Planning Application Number: 24/00854/REM

Application Address: Land East Of The Windmill Inn Brascote Lane Newbold Verdon Leicestershire

Description of Application: Re-consultation. Application for Reserved Matters (site layout, scale, appearance, and landscaping) of outline planning application 22/00277/OUT for 239 dwellings with associated internal road layout, car parking, drainage, and landscaping.

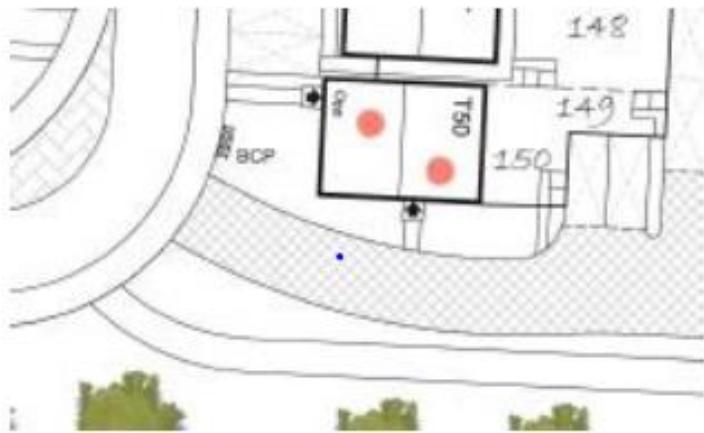
However, this raises the issue of the road currently proposed to serve plots 64, 65 and 76 as demonstrated below:

This road currently fails to provide the required number of direct frontage access points required for adoption (which is six), therefore it will need to remain private. If the developer wishes to extend the site using this road, they will need to note that LCC will not adopt this road unless it provides the required number of direct frontages. The developer would be required to put this road up for adoption at this time. The Applicant should note that Policy 5 of the LHDG states that sites should not be linked by private through roads. Policy 5 can be found [here](#), this situation also applies to West Lane and any other spur roads with five or less direct frontages.

Please note, even if the road provides access to private drives this is not counted as direct frontage access.

The proposed junction spurs to the roads that fail to comply with the LHDG design requirements for adoption will need to be removed and vehicle footway crossover points detailed.

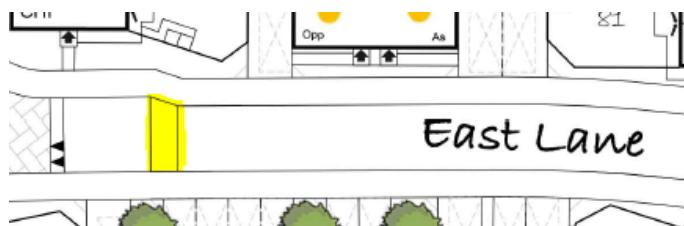
Raised table issue - The design details a junction speed table (Shown below) is to be located very close to the ramp to access East Lane, this would be required to be removed to enable adoption.
